**Decision Maker:** Environment Portfolio Holder

**Date:** 15<sup>th</sup> March 2018

**Title:** GREENWICH TO KENT HOUSE QUIETWAY (BROMLEY SECTION) PUBLIC CONSULTATION REPORT AND FINAL PROPOSALS

## Appendix 6 Proposed land acquisition

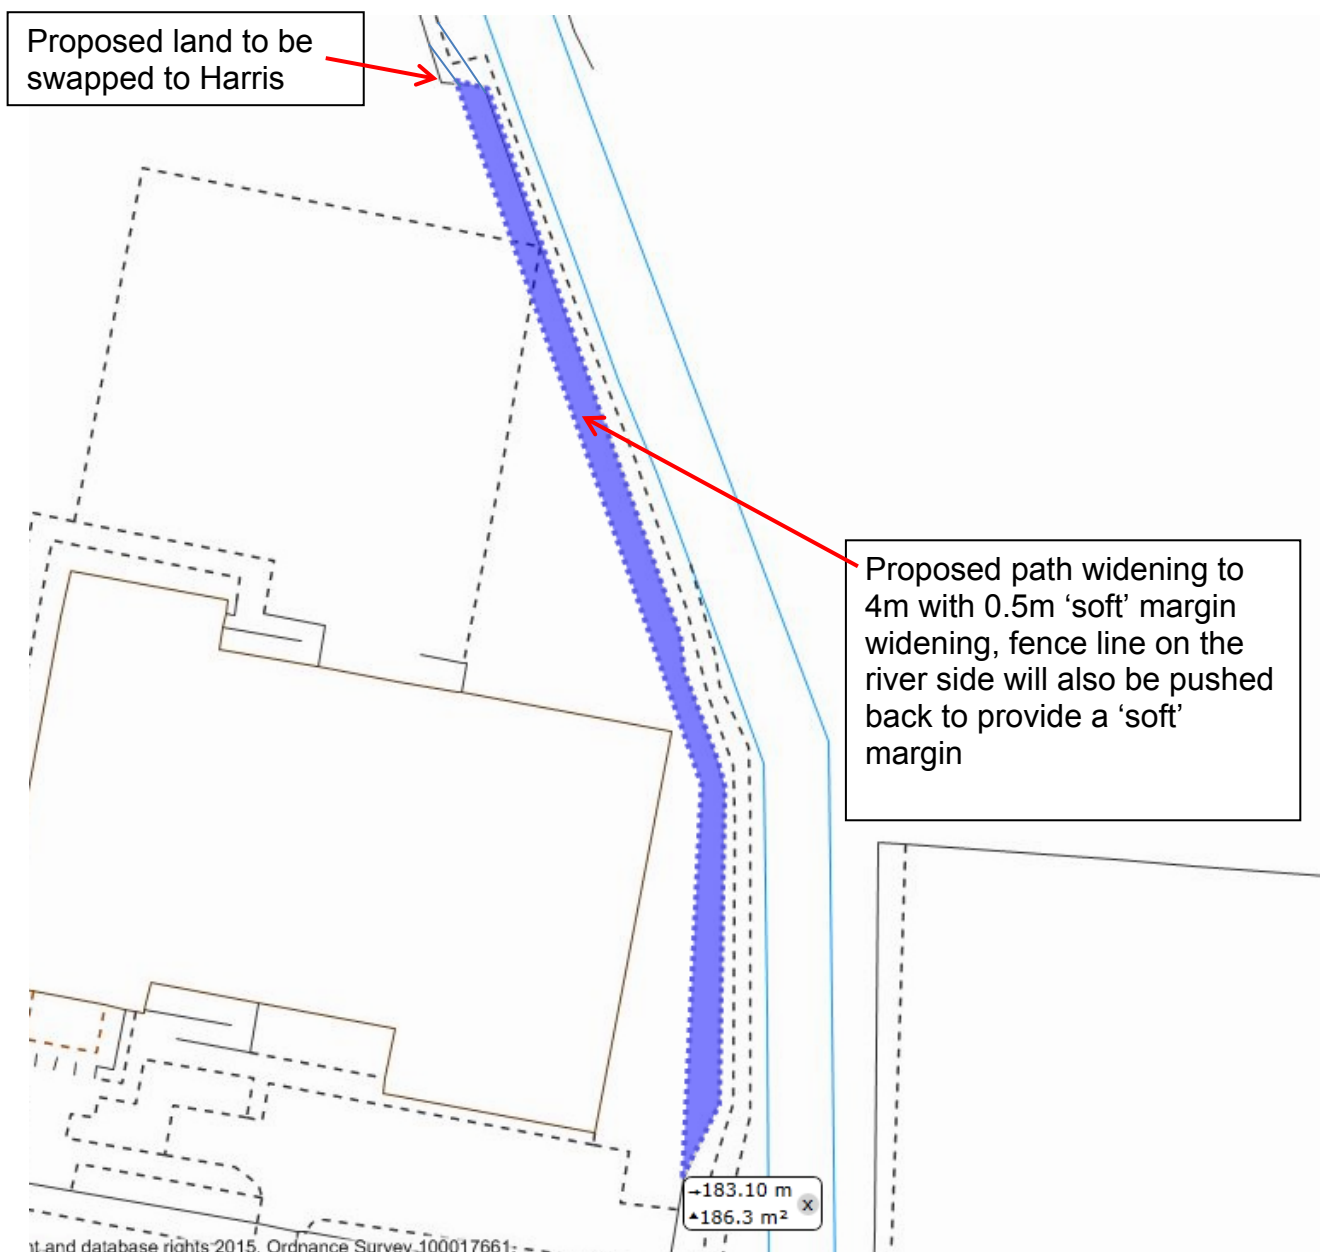
- 186.3 sq.m. of land to be acquired from Harris Aspire
- 5.5 sq.m. of land returned to Harris Aspire
- Net acquisition of 180.8 sq.m. of land from Harris Aspire
